**PARTIAL REFLECTED CEILING PLAN BUILDING F**

**REFLECTED CEILING PLAN BUILDING D**

BAKERSFIELD  
 CITY SCHOOL  
 DISTRICT

MODERNIZATION AT  
 CURRAN MIDDLE  
 SCHOOL  
 FOR:

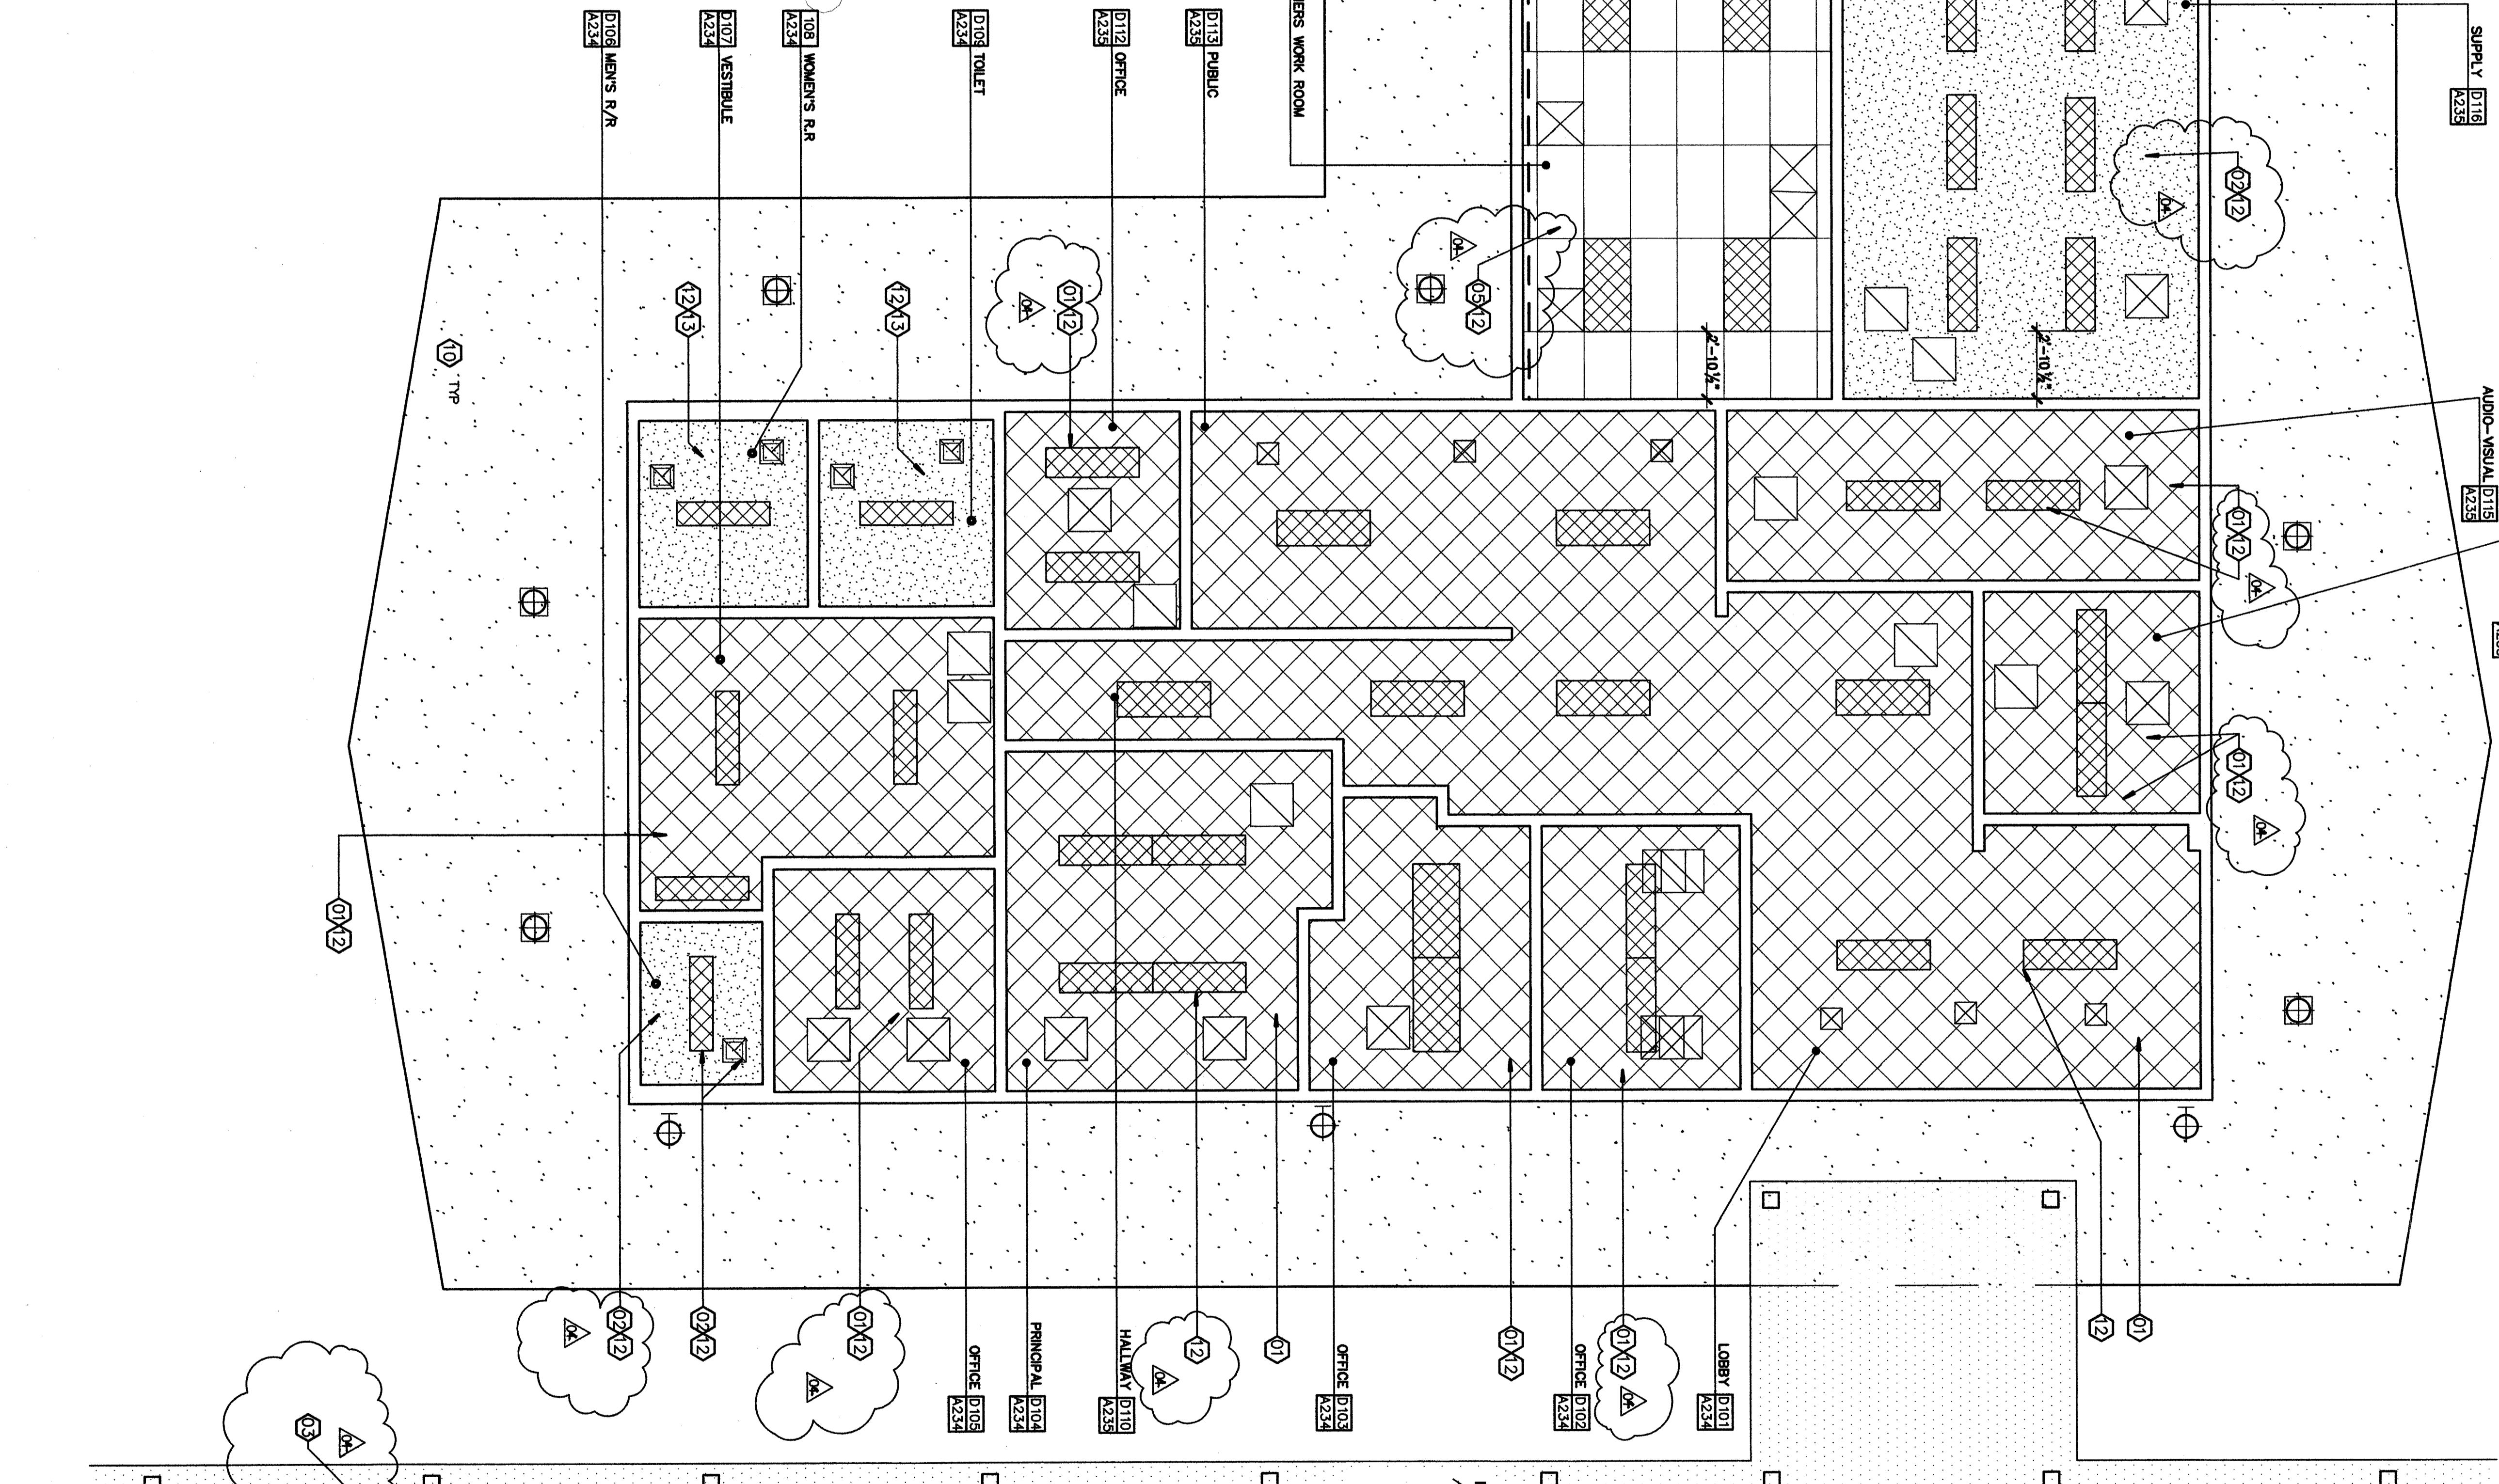
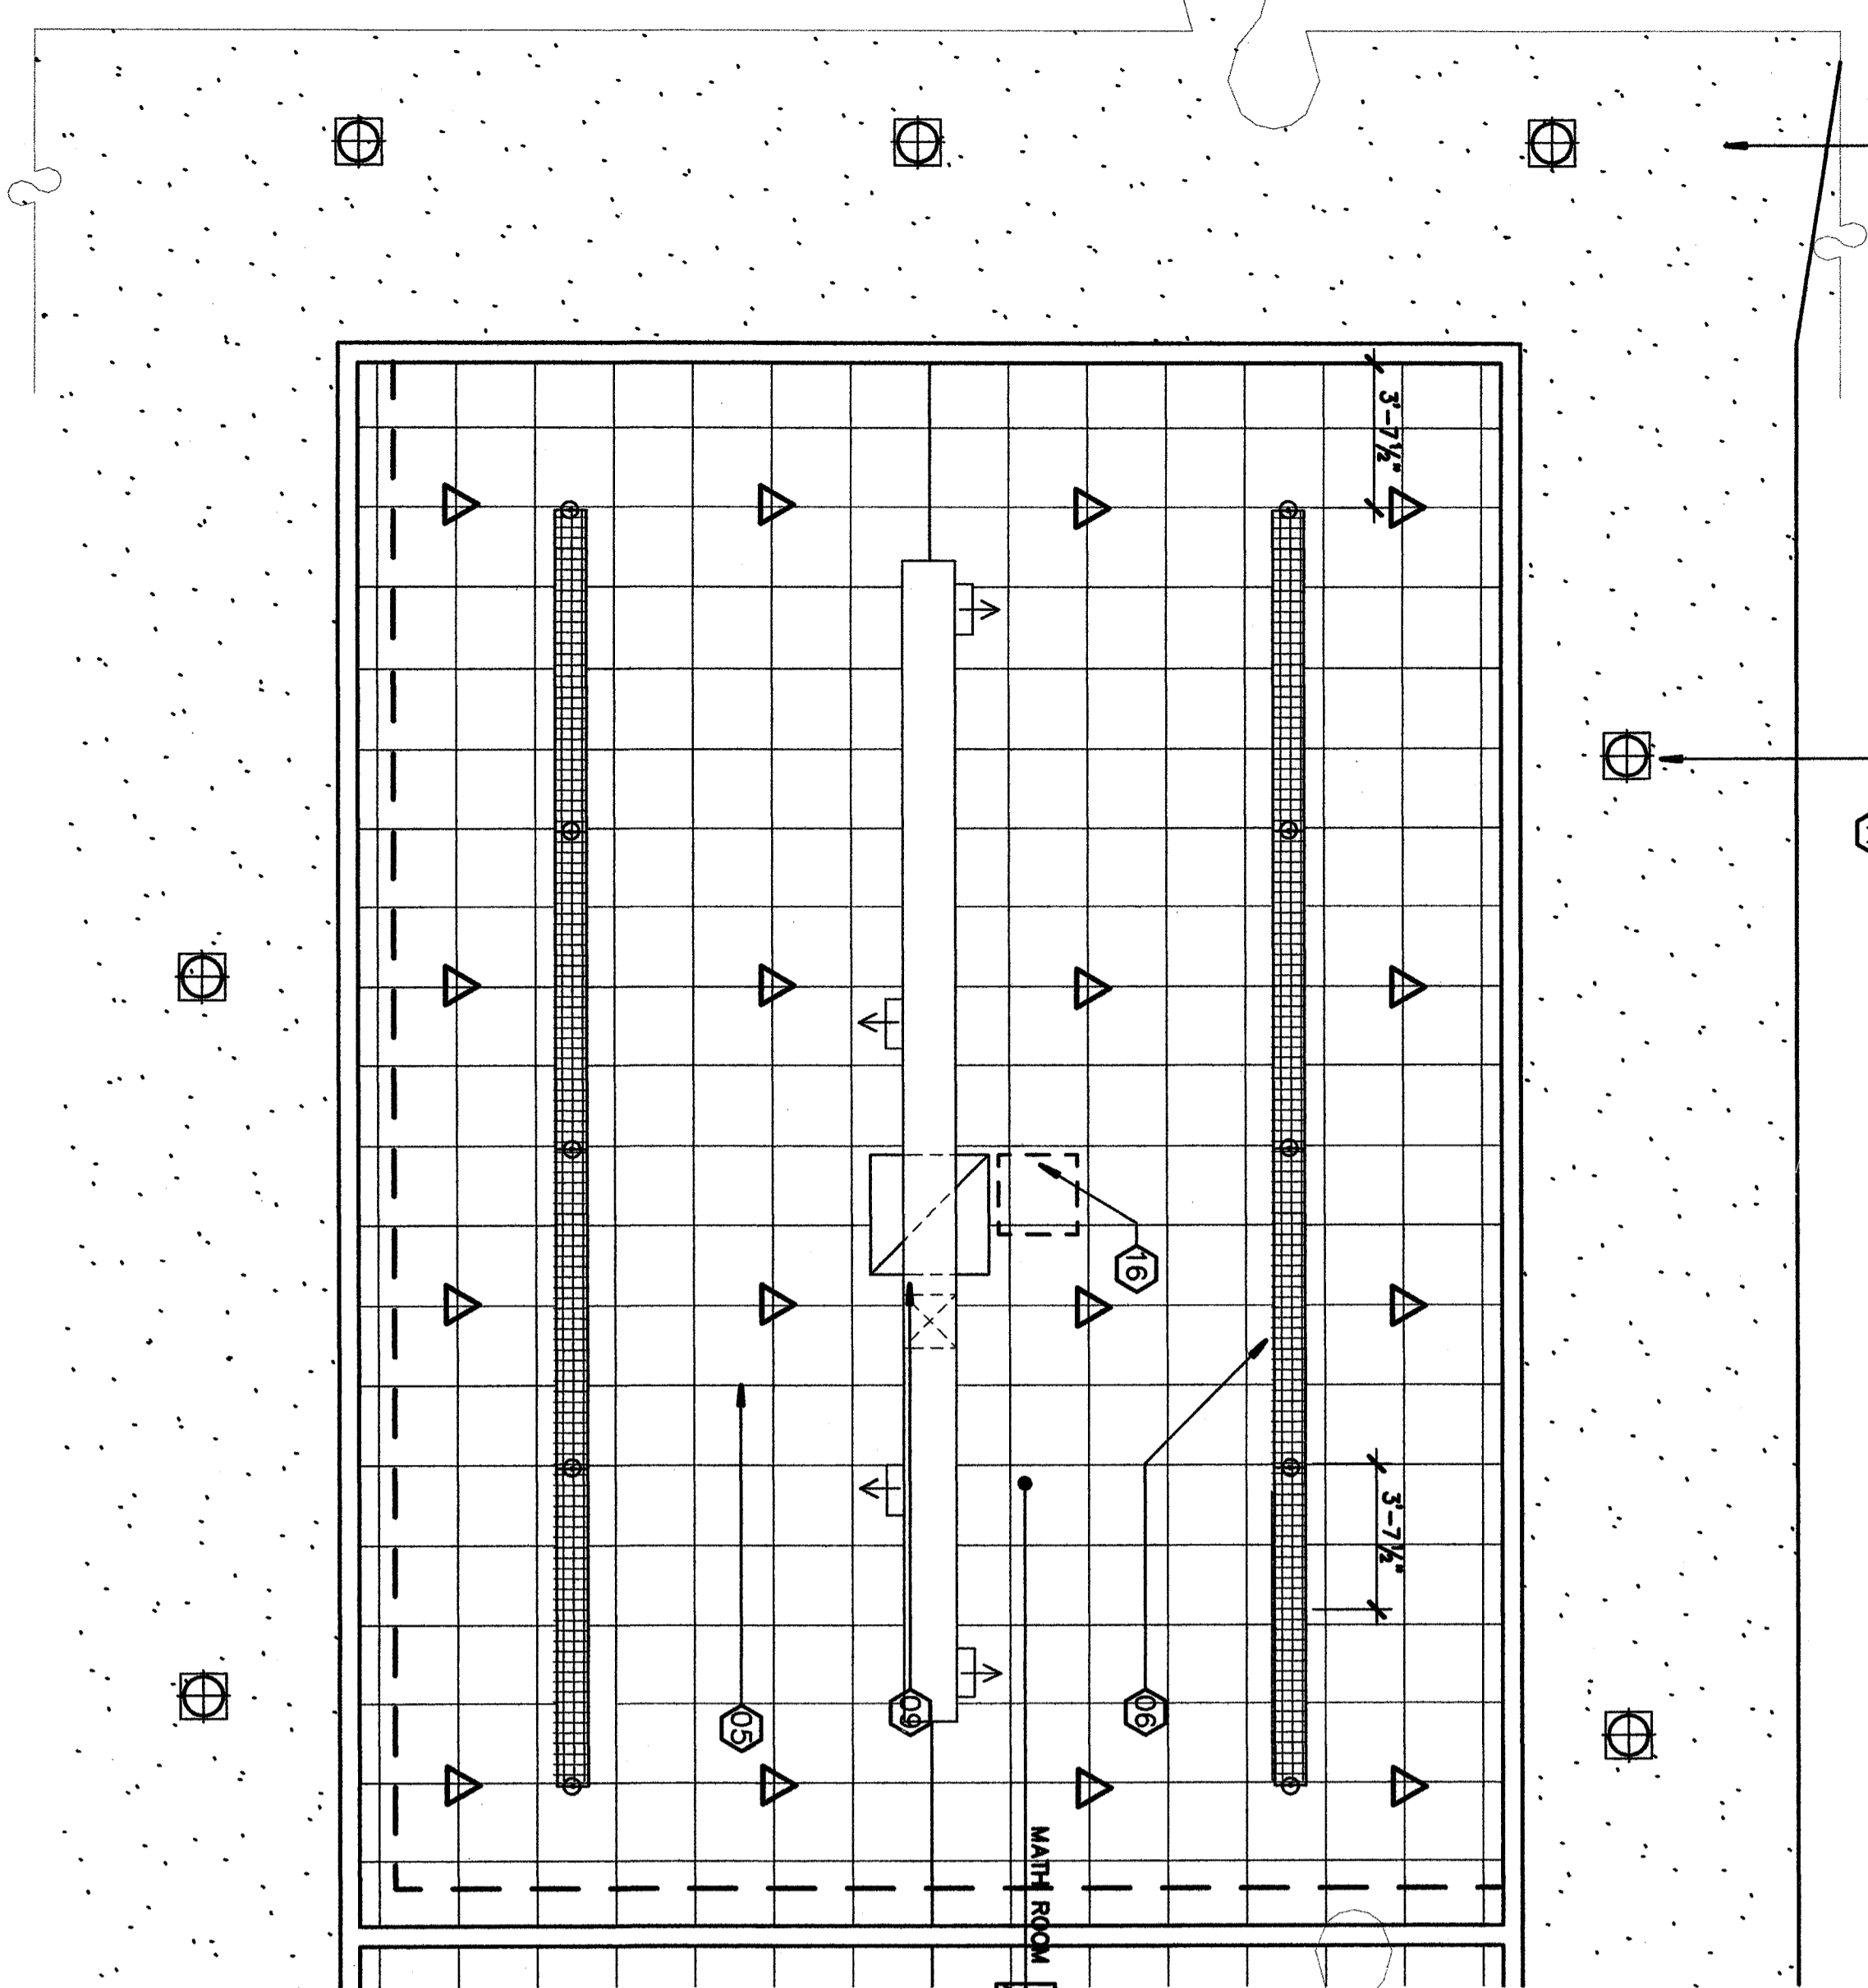
Item No. 30 Refer to Sheet A-432  
 4/1/04  
 Revise Keynote #03 to read "Existing covered walk to be removed by others. Delete Keynote #08. Revise Keynote #11 to read "New exterior lighting to be provided as required-per electrical drawings. See detail A-501. Cut T-Bar acoustic tile as required allowing metal frame attachment from roof joist above. Update project register and append to project register from project register. Adjust dimension as required to detail to roof joist above."
